The State of New Hampshire
DEPARTMENT OF ENVIRONMENTAL SERVICES

May 29, 2009
Letter of Deficiency
DSP#09-056

RE: Upper Reservoir Dam #108.06, Hanover

A

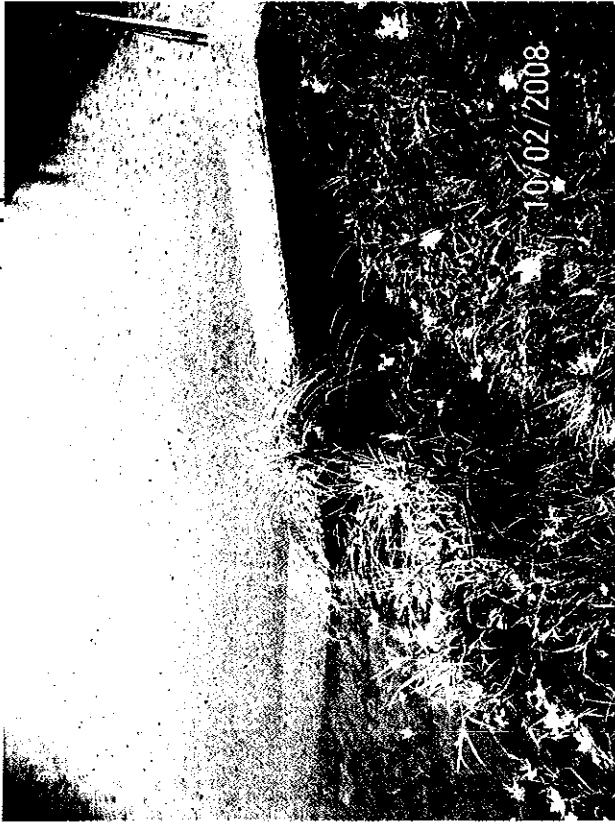
2. Replace the missing embankment material on both sides of the spillway. See photographs A and B.
 3. Remove the minor brush from the rip rap on the upstream slope of the dam. See photograph C.

D

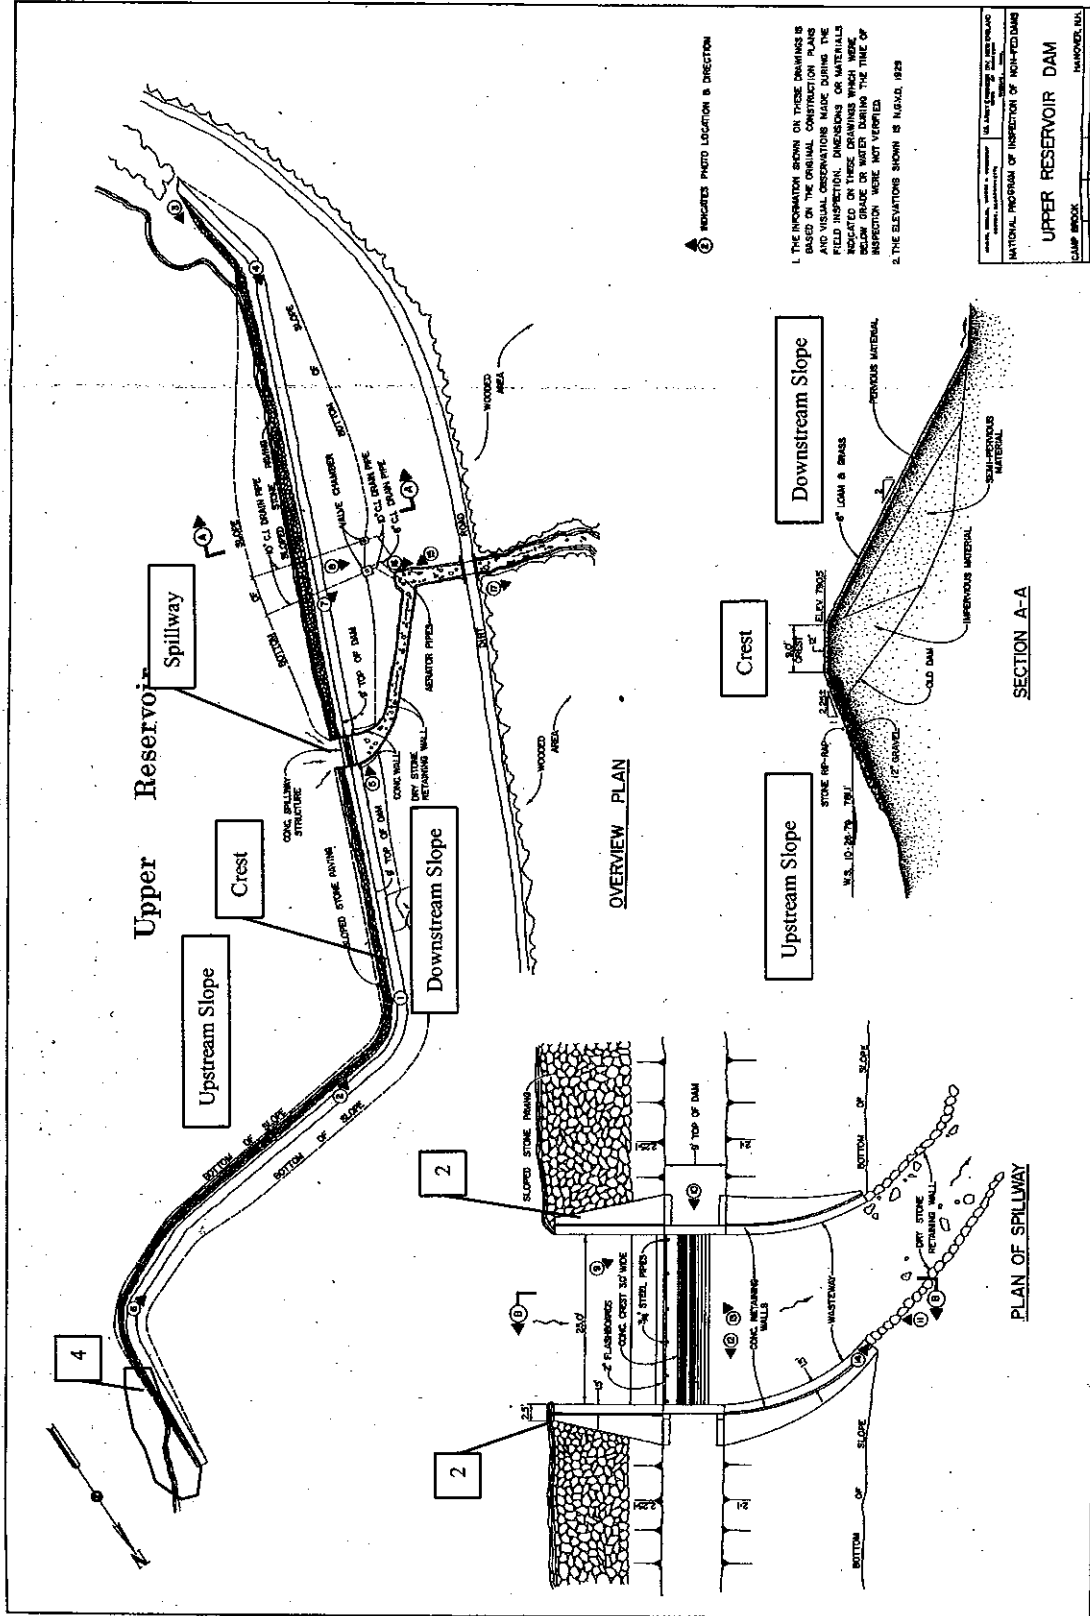
4. Remove the brush located at the far right end of the dam on the upstream slope and for a distance of 15 feet beyond the footprint of the dam. See photograph D.
